## **6.0 DESIGN PROPOSAL**

**DESIGN DEVELOPMENT**

The first meeting was held with Oxford City Council on the 10th October 2023. S&P presented an initial scheme involving the demolition of all buildings to be replaced with a single laboratory-office building. This included design development from initial parameters discussed with Oxford City Council in other pre-application discussions.

## PROPOSED REAR ELEVATION

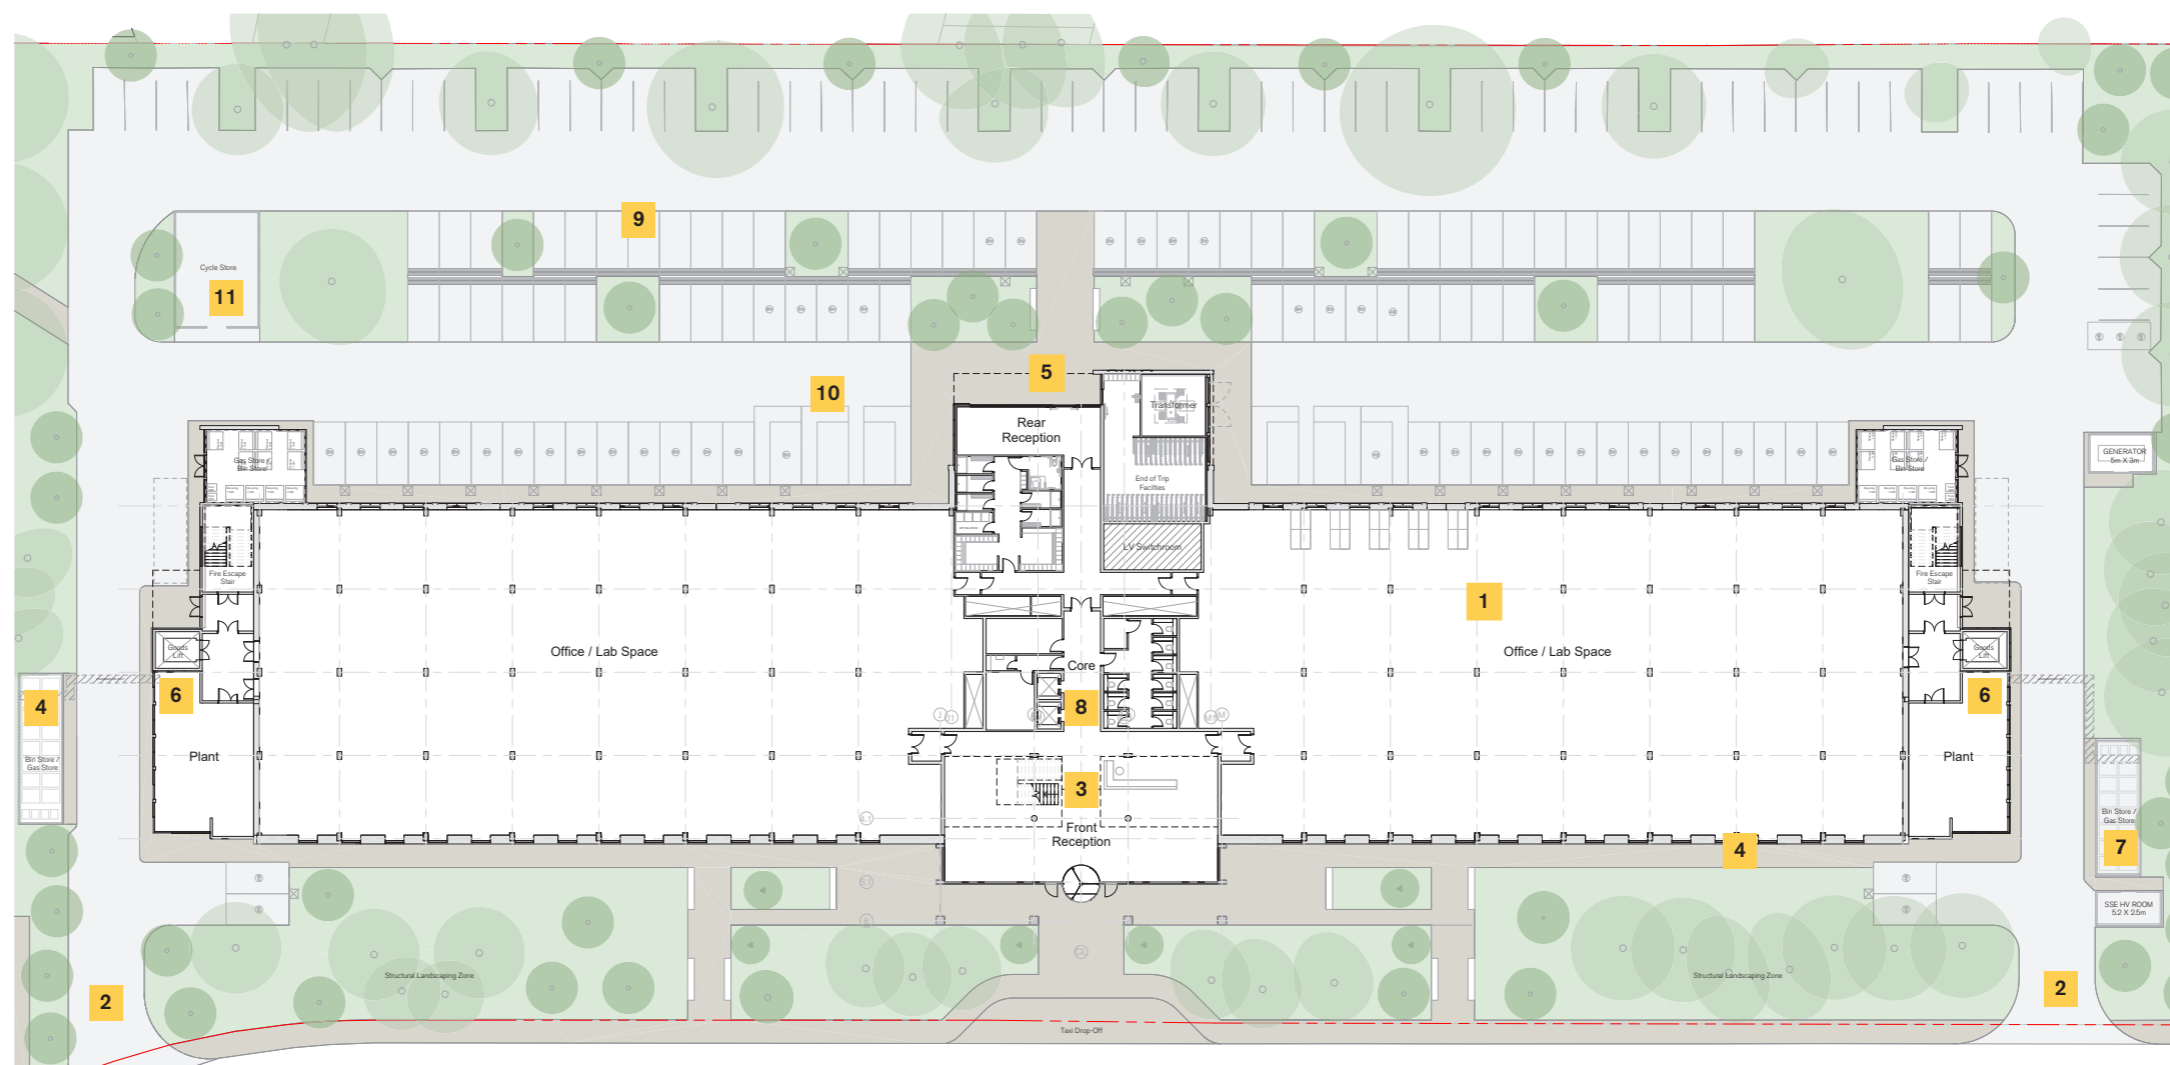
- The bulk and massing of the proposed building appear acceptable, subject to the supporting justification referred to at the first bullet point above. The design rationale, informed by the lab grid, is understood and the proposed footprint responds well to the plot dimensions although, **careful consideration needs to be given to potential overshadowing on neighbours and overlooking/ perceived overlooking.** *Slim windows/ fins could go some way to mitigate this.*

The final iteration of the rear elevation studies resulted in a simpler elevation broken down with more solid panels when compared to the front elevation.

The elevation controls and underplays the glazed openings as to consider the sympathetic to the residential area to the west of the site.
